## INSTRUCTIONS TO PERFORM CAMPAIGN 127 (Era® Models 144U, 170A, 170R, and 170X) (View® Profile/Navion® iQ Models 524G and 524V)

Certain 2009 through 2013 model year Winnebago Industries Era (Models 144U, 170A, 170R, and 170X) and Winnebago View Profile/Itasca Navion iQ (Models 524G and 524V) motorhomes.

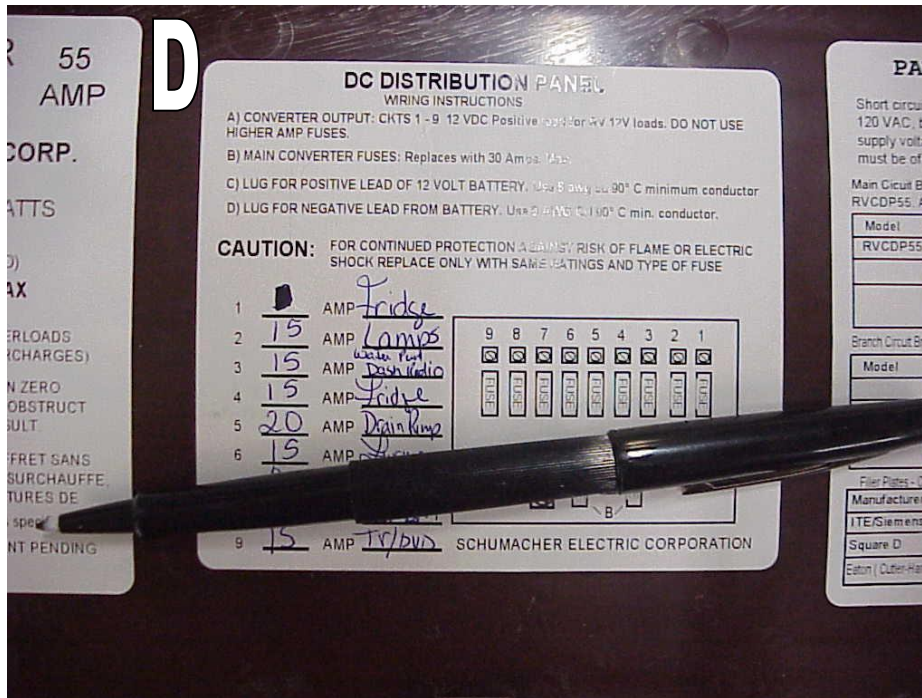
3. View "DC Distribution Panel," label to locate the 5-amp. (tan) refrigerator fuse (generally the far right fuse in the power center). Remove the current 5-amp. (tan) fuse and discard. **NOTE: There is also a 15-amp. refrigerator fuse. Do not change the 15-amp. refrigerator fuse.** See Photo B.

4. Install new 3-amp. (violet) fuse (from kit) into socket. See Photo C.

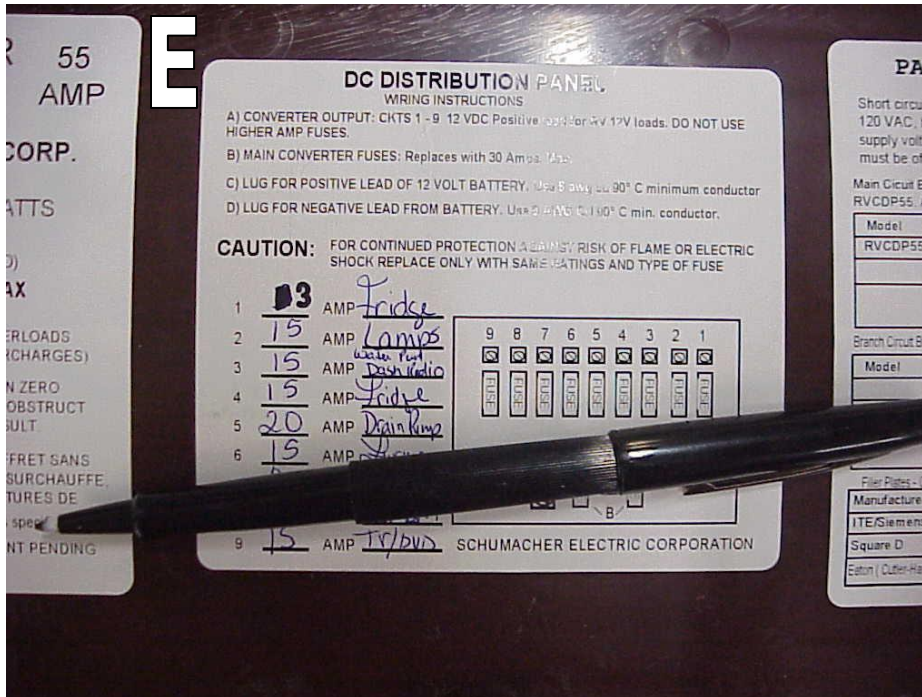
- On the "DC Distribution Panel," label with a permanent marker, black out the "5" and write in a "3" for the refrigerator. See Photos D and E.

(With a Permanent Marker, Black Out the "5" on Line 1)

(With a Permanent Marker, Black Out the Number "5" and Write In "3")
